5311 SADDLEWOOD LN

Groundwater and Wastewater Services File Imaging Project

RE: Property located at 5311 Saddlewood
FILE: 4194A
PARCEL: 135-312-12

Receipt of your plans for a modified waste disposal system for the property referenced above is acknowledged.

Lot 12 Hidden Hills
F.Ic. # 419#A

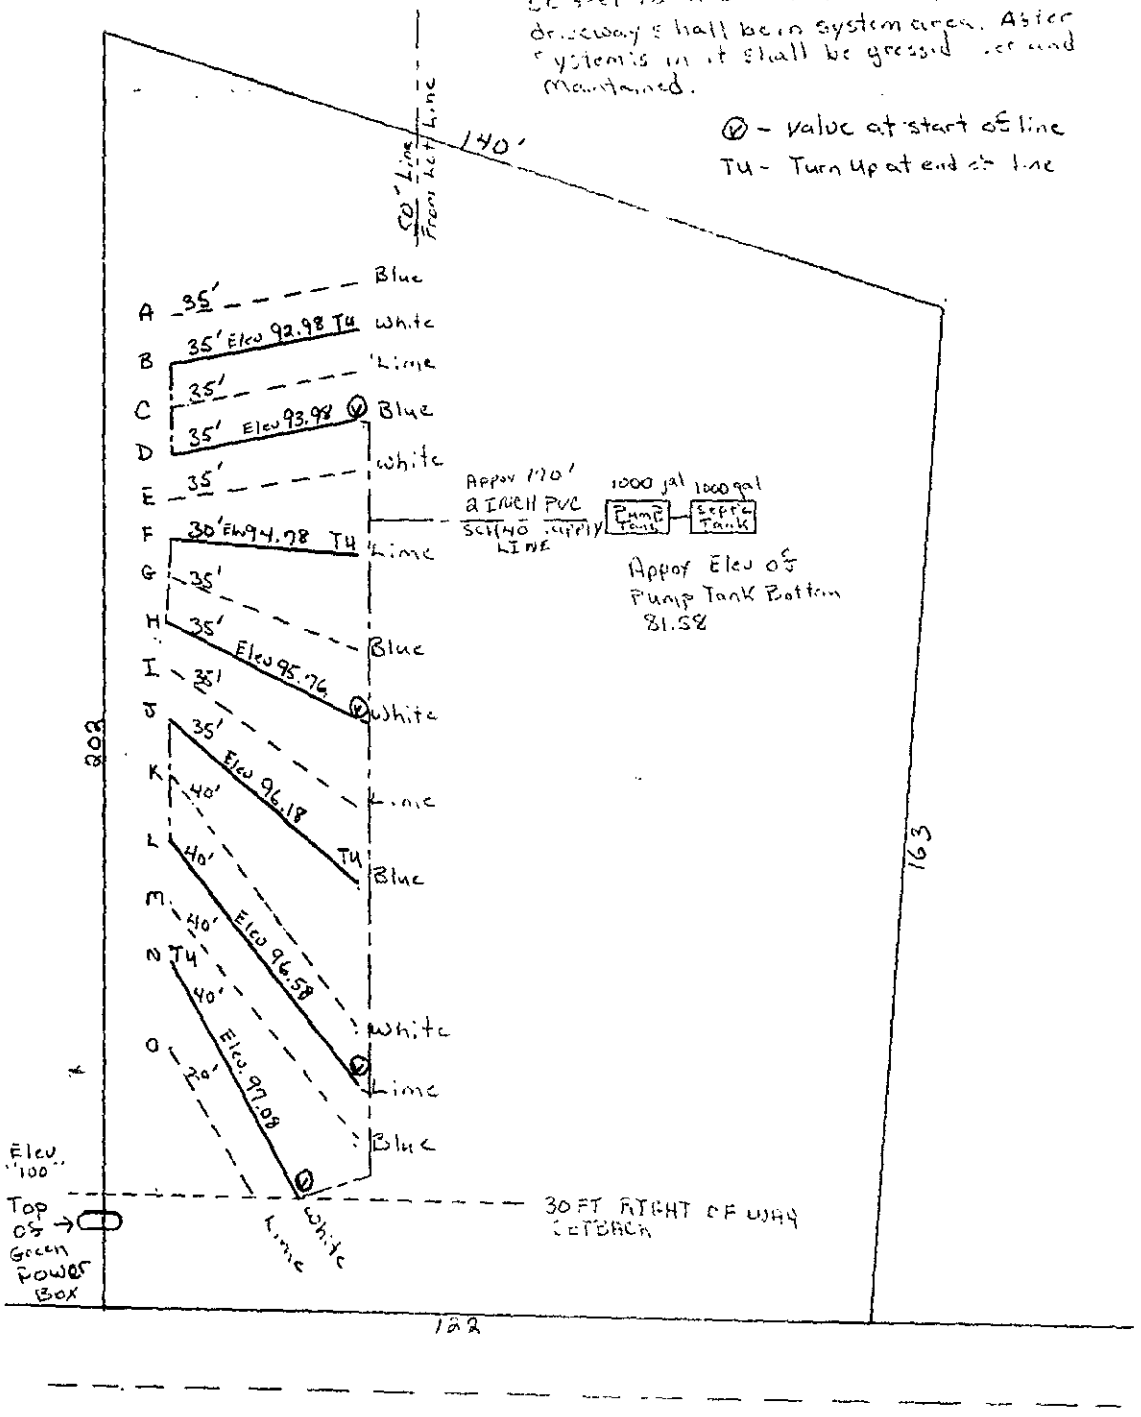
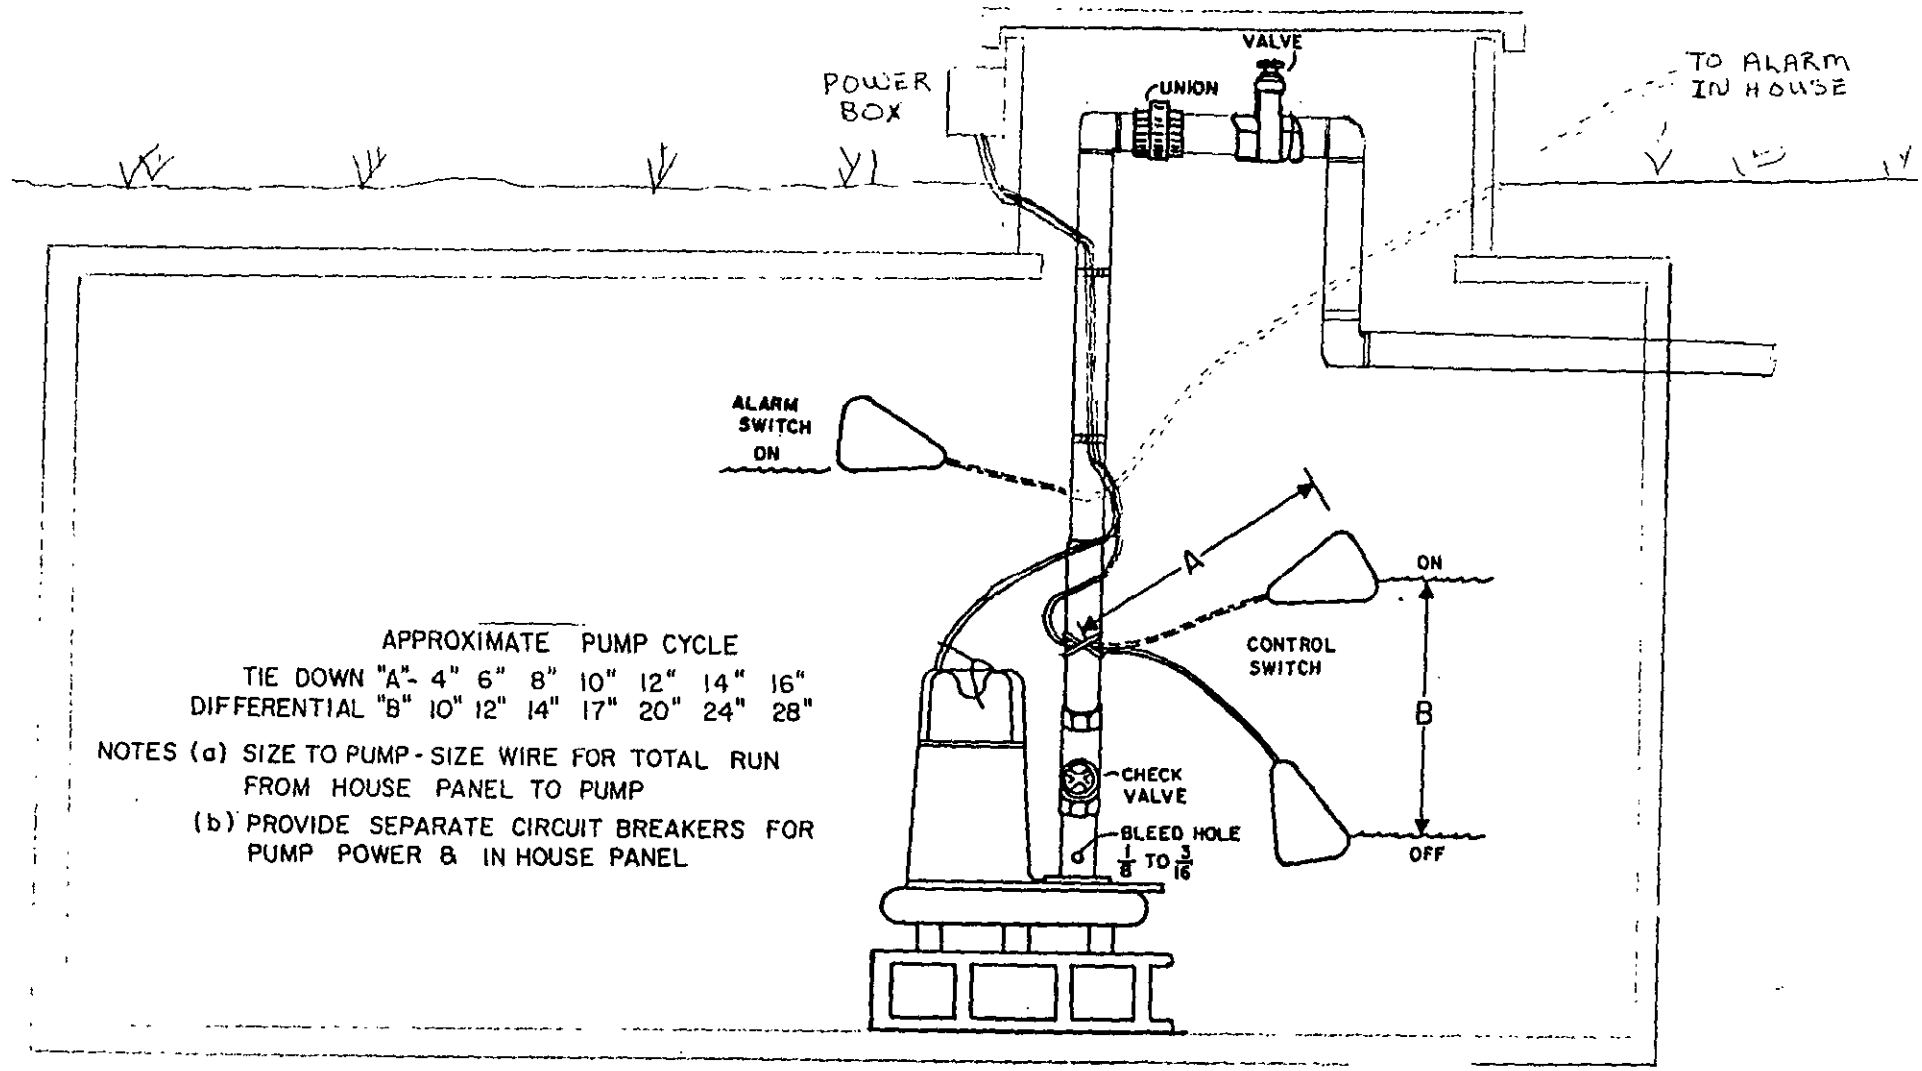
Your plans for the modified system for the above property as submitted are approved with the following comments:

- The well should be located 100 feet or no less than 50 feet away from any part of the sewage disposal system and repair area.
- Water saving plumbing devices and low flush or microflush toilets must be installed when constructing the residence.
- Occupants to utilize maximum water conservation measures wherever possible.
- Trench walls to be raked and limed.

PROPOSED PLOT PLAN

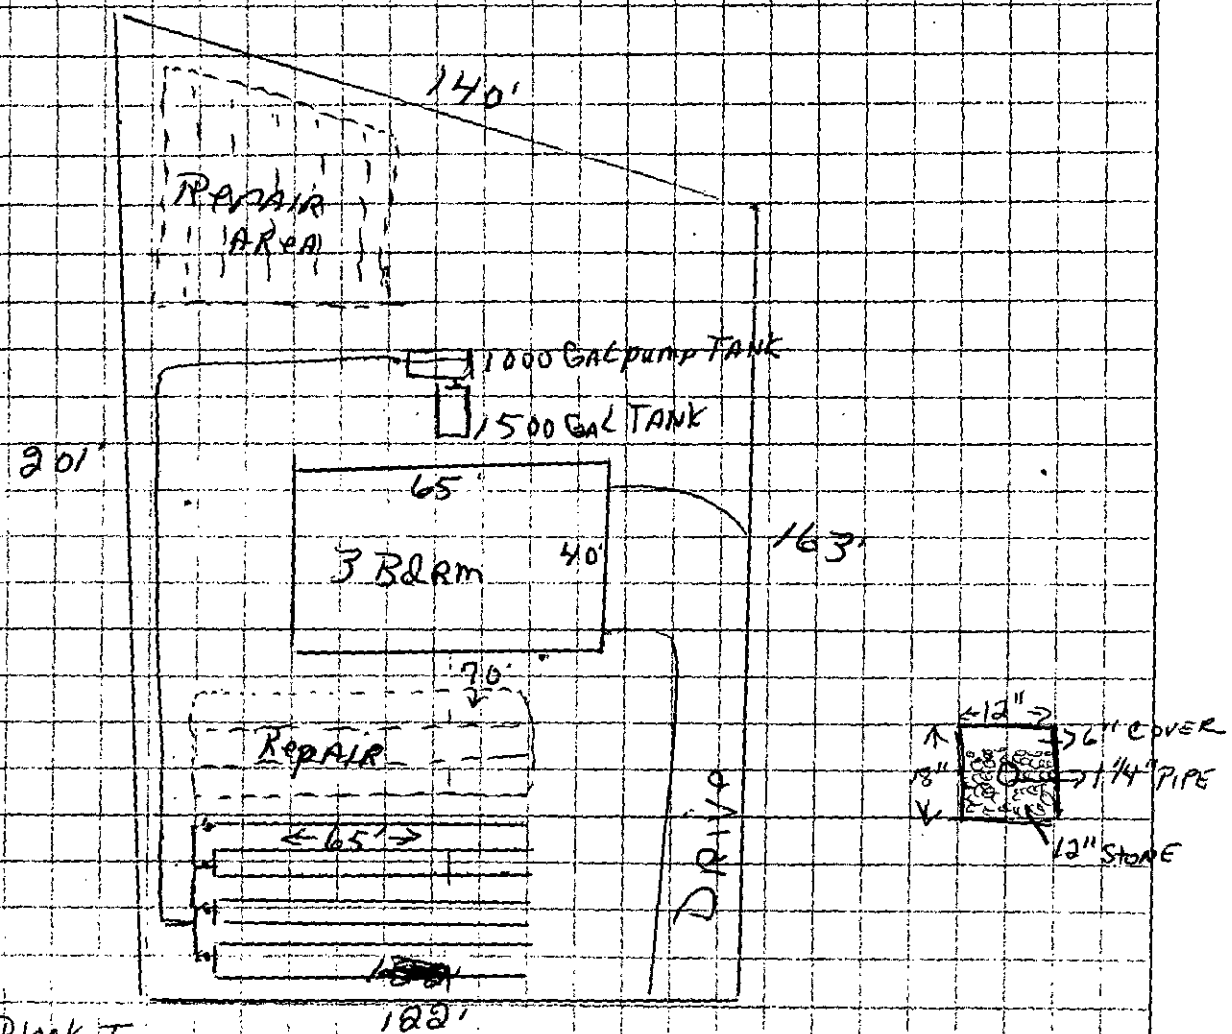
Receipt of the plans and specifications for a modified system of sewage disposal proposed for installation at the above referenced property is hereby acknowledged. Upon receipt of the plan, a review was made of the material on file and a site evaluation was conducted. The plan was then reviewed in conjunction with provisions of 10 NCAC 10A .1900, "Laws and Rules for Sanitary Sewage Collection, Treatment and Disposal". Our comments are listed below:

> Several calculations need specific revision. I have indicated these on your proposal. Please resubmit with necessary corrections.

For this reason, the plans as submitted are disapproved.
